Addendum No. 1

Project Name:	DDSB Brock HS	Date:	July 16, 2024
Description:	PLP Alterations	From:	Brad Timson, P. Eng.
Address:	C1590 Concession 12 Cannington, ON	Project No:	Z0013706
Client Contact:	Chris Thaler, DDSB	DDSB Tender No:	T24-36

Questions/Responses

3 DEMOLITION SECTION DETAIL
 A104 BROCK HS - SECOND FLOOR - LAUNDRY 320A

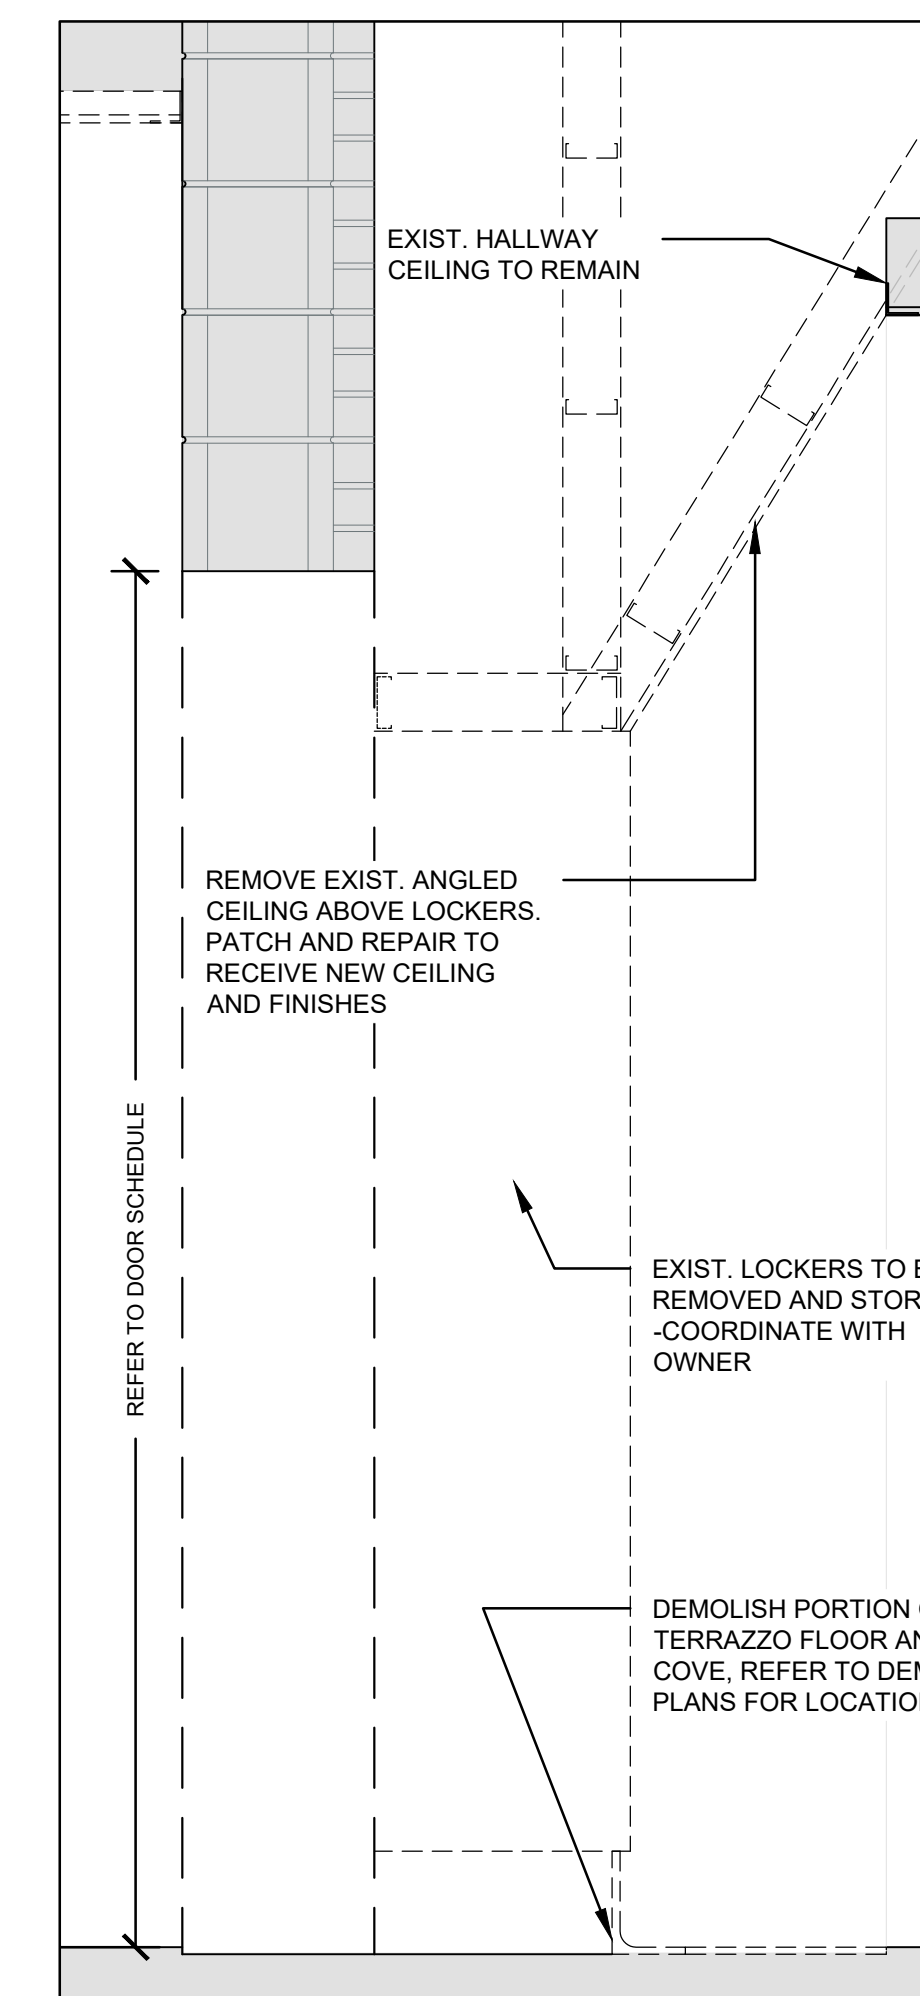
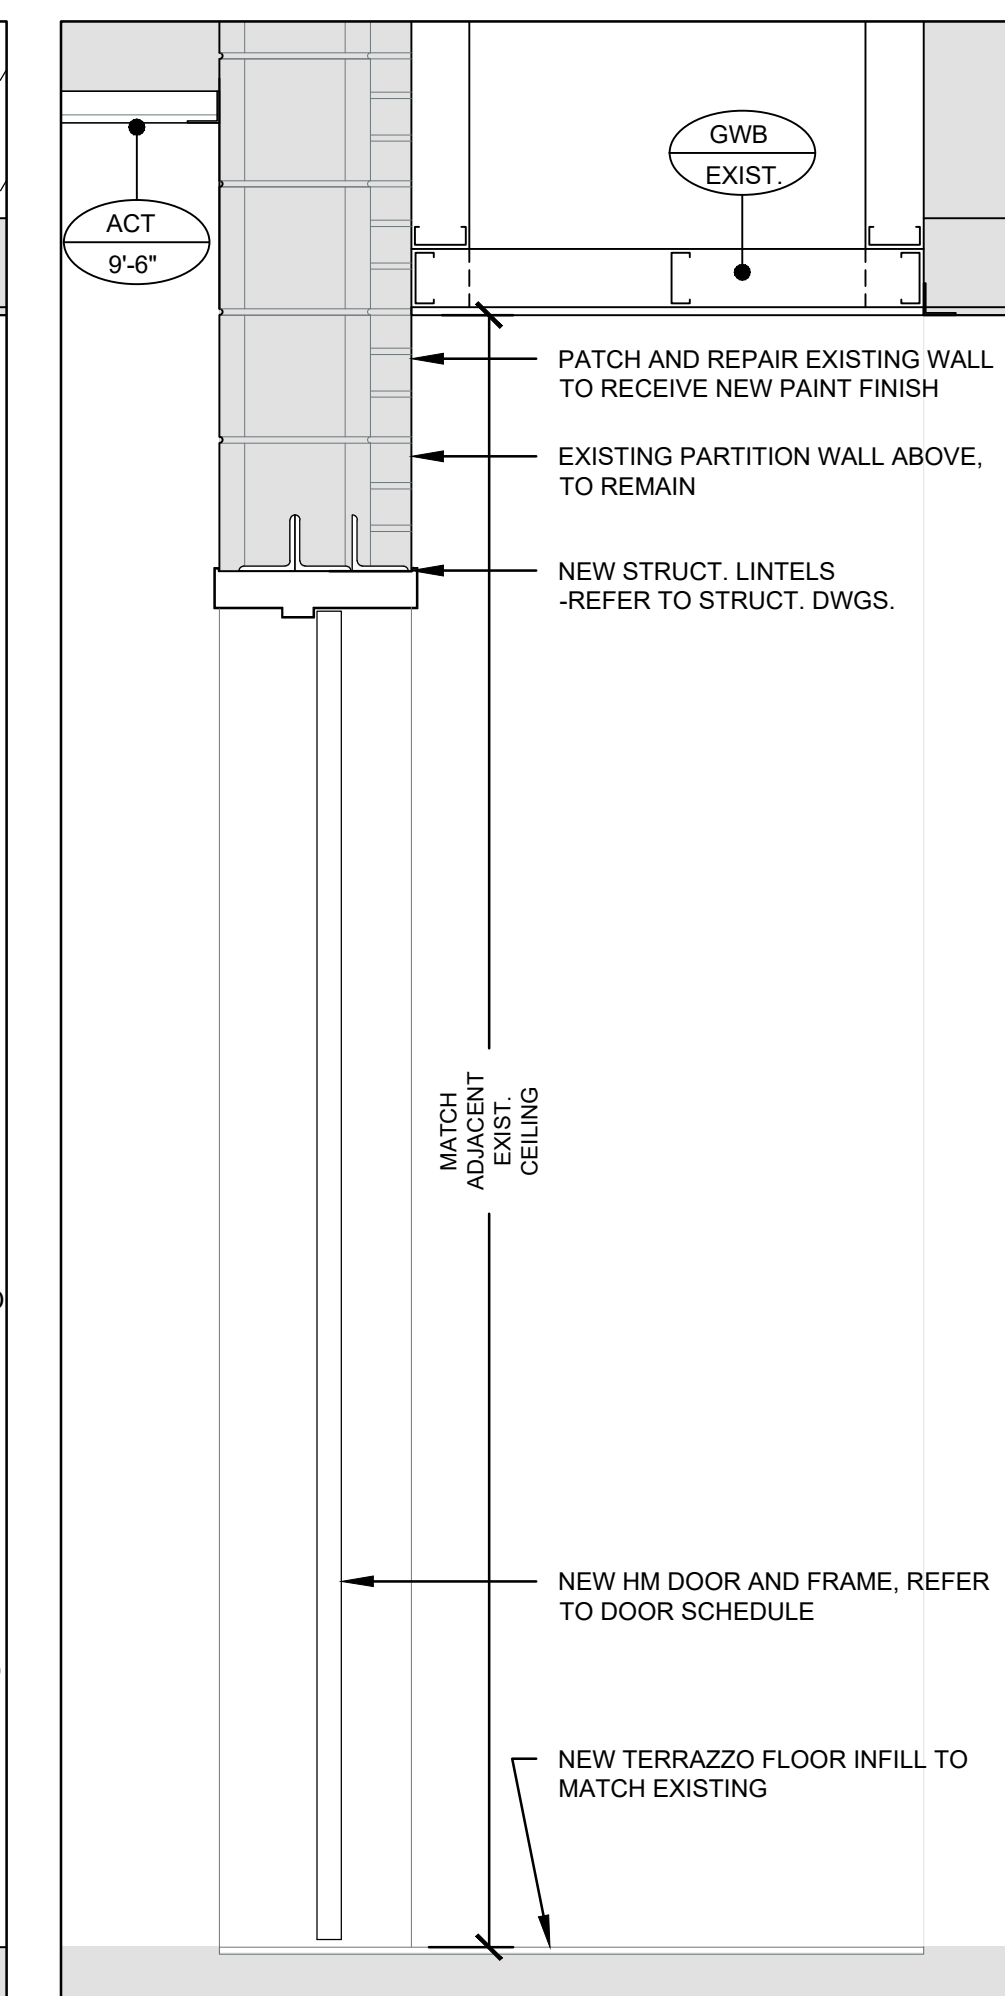
1.23 **Question:** Detail 3/A104 – Please confirm removal of concrete locker base is required.

Response: Yes, all concrete, blocking and other locker supports under lockers must be removed to make floor level for new door.
